Access Compliance Report

Public Rights-of-Way

(Curb Ramps)

Intersection ID: 15246	Main Street: HEFLIN_ST	Cross Street: MCVAY_ST	Location: NE
ADA ID: B757421A3191	Ramp Type: Perp	Initial Pass/Fail: Fail	Overall Compliance: No
Severity Score: 12.5			
Codes/Mitigation Info/Possible Solution		Field Measurements/Component Compliance

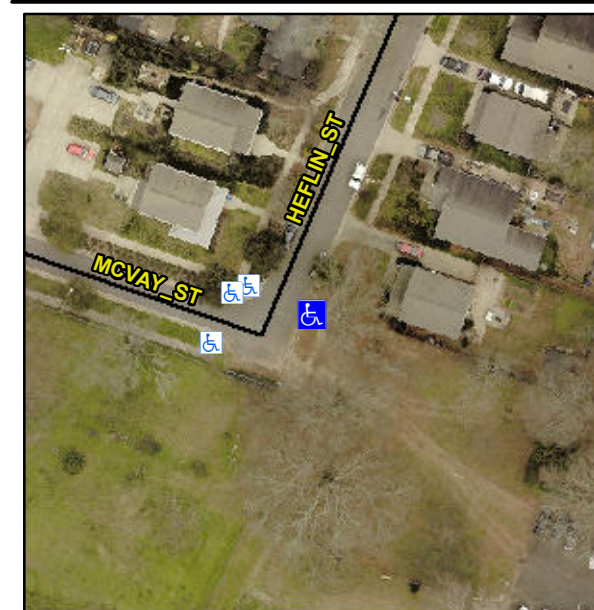
Not Found, R304.2.2

Compliance	Description	Data	Compliance	Description	Data
N/A	Ramp Length (in)	75.0	No	Ramp Slope (%)	8.5
Yes	Ramp Width (in)	59.0	Yes	Ramp XSlope (%)	1.3
N/A	Flare Type LT	N/A	N/A	Flare Type RT	N/A
N/A	Flare Slope LT (%)	N/A	N/A	Flare Slope RT (%)	N/A
N/A	Flare Traversable LT?	N/A	N/A	Flare Traversable RT?	N/A
N/A	Landing Length (in)	N/A	N/A	DWS Provided?	N/A
N/A	Landing Width (in)	N/A	N/A	DWS Contrast?	N/A
N/A	Landing Slope (%)	N/A	N/A	DWS Length (in)	N/A
N/A	Landing X Slope (%)	N/A	N/A	DWS Full Width?	N/A
N/A	Landing Curb? (Y/N)	N/A	N/A	DWS Offset (in)	N/A
N/A	Shared Landing?	N/A			
N/A	Gutter Ponding?	N/A	N/A	Gutter Slope (%)	N/A
N/A	Gutter Lip Ht (in)	N/A	N/A	Gutter X Slope (%)	N/A
N/A	Painted X Walk1?	No	N/A	Painted X Walk2?	N/A
	X Walk 1 Direction	To NW		X Walk 2 Direction	N/A
N/A	X Walk 1 Width (in)	N/A	N/A	X Walk 2 Width (in)	N/A
	X Walk 1 Slope (%)	2.9		X Walk 2 Slope (%)	N/A
	X Walk 1 X Slope (%)	0.5		X Walk 2 X Slope (%)	N/A

Remove & Replace Entire Ramp.
